**NSLPP MEETING HELD ON 05/06/24****Attachments:**

ADDRESS/WARD: 184B, 186 and 190 Kurraba Road, Kurraba Point

APPLICATION No: DA 343/22

PROPOSAL: Demolition of a dwelling house, two (2) dual occupancies and a swimming pool, and construction of two x residential flat buildings and 2 x dual occupancies, with basement parking and access provided by car lifts, associated landscaping and civil works and internal boundary realignment and subdivision.

Figure 12: Excerpt from calculations Sheet A401, with areas incorrectly included in site coverage shown shaded red

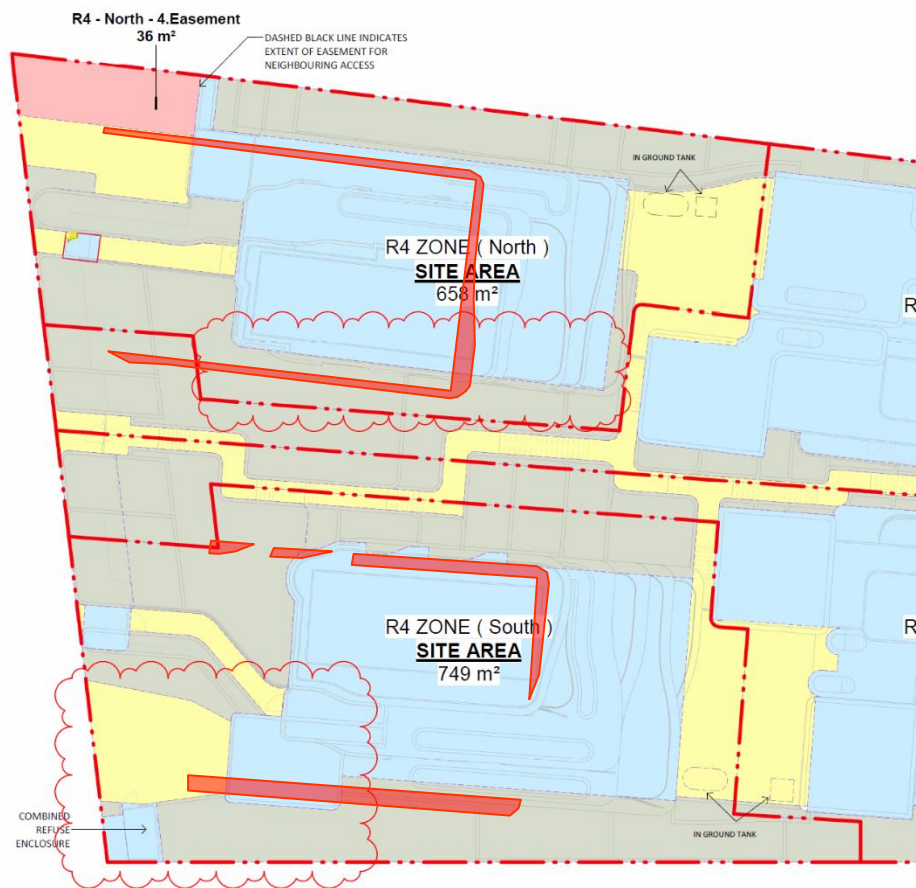
Following the above, the calculations provided for site coverage are also inaccurate where a portion of the built form for both Buildings A and B have been excluded from the site coverage calculations, and are subsequently included in landscaped area, as shown in the Figure below (extract from A401). The following site coverage calculations are obtained for Buildings A and B:

- **Building A:** Approximately 300m² of site coverage; and
- **Building B:** Approximately 353.5m² of site coverage.

Figure 13: Excerpt from calculations Sheet A401, with areas incorrectly included in landscaped area shown shaded in red

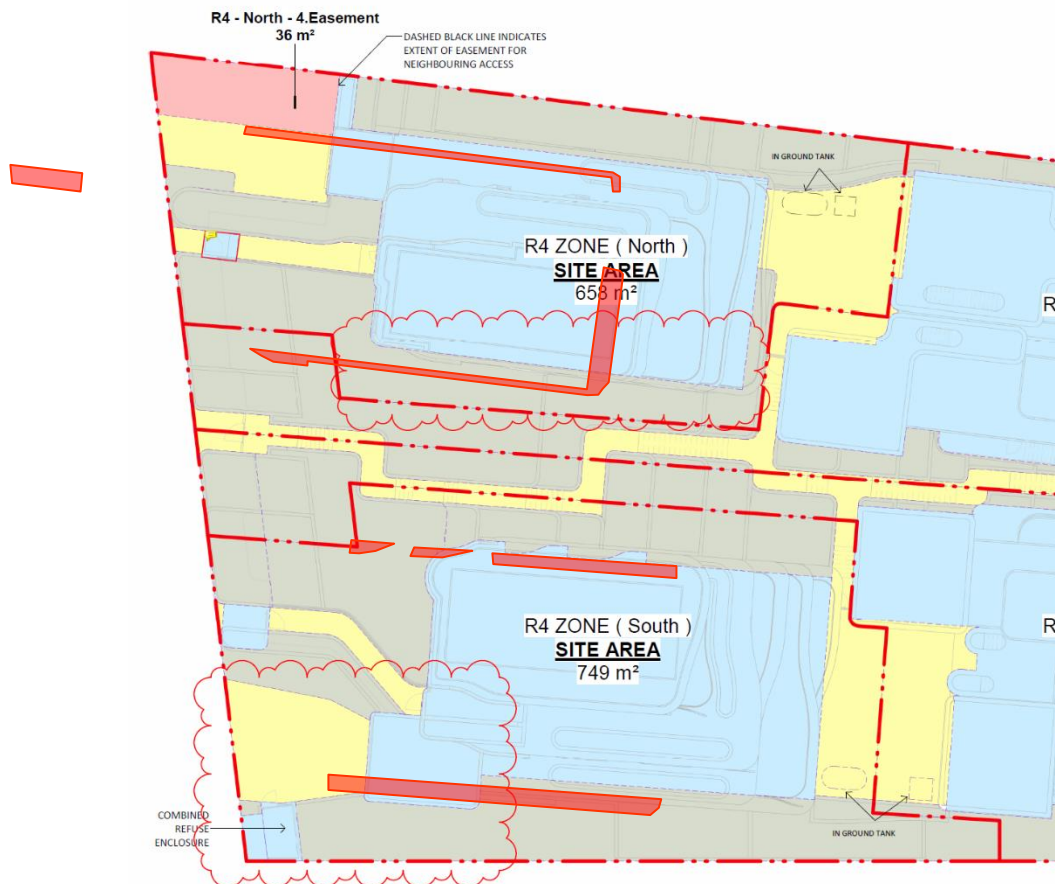
- **Building A:** Approximately 216m² of landscaped area; and
- **Building B:** Approximately 284m² of landscaped area.

It is also noted that Sheet A402 differs from Sheet A401 in terms of areas included in landscaped calculations. For consistency Sheet A401 has been relied upon. It is noted that the Applicant has stipulated that these areas should be included in landscaped calculations as they include vegetation above, however, this is not consistent with P2 above.

Figure 14: Side Setback Plane A101, with existing ground RL21.94 and 3.5m 45° incline plane, with 3m setback determined from envelope.

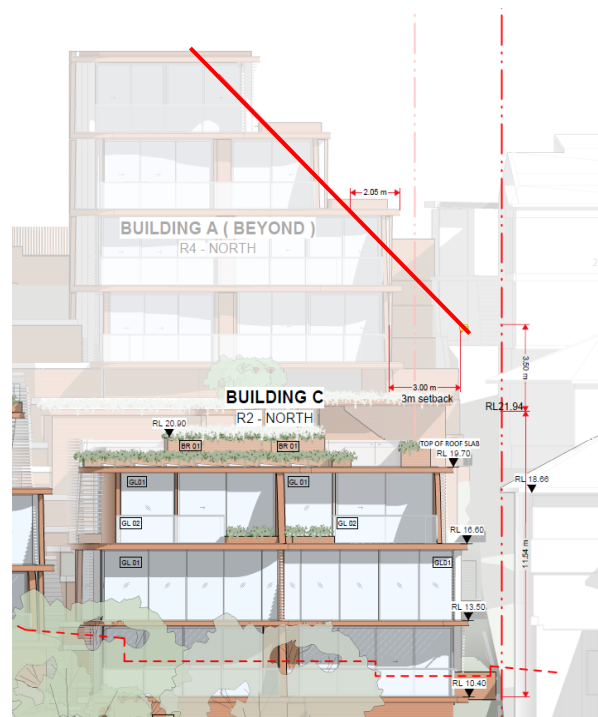
Further to the above, an objection has been made in terms of the accuracy of the side setback incline plane of Building A to the northern boundary. As outlined in this Report, the side setback incline planes have been based on the existing ground levels along the northern (side) boundary, per A620, as to inform the diagrams of A412. As shown in the Figures below, the extent of non-compliance to A101 and A201 (lower and upper levels) is consistent with that depicted in A412. Specifically, the roof form of A101 to the north is non-compliant by 2m and pertains to a relatively minor portion of the parapet roofing and glazing which does not result in any adverse impacts. As the topography rises considerably, the extent of variation will reduce as shown in A412. In terms of A201 (low and upper levels), the extent of non-compliance is negligible and pertains to parapet roof elements.

In accordance with the above, the non-compliance with the side setback incline plane is considered acceptable and consistent with that shown in A412.
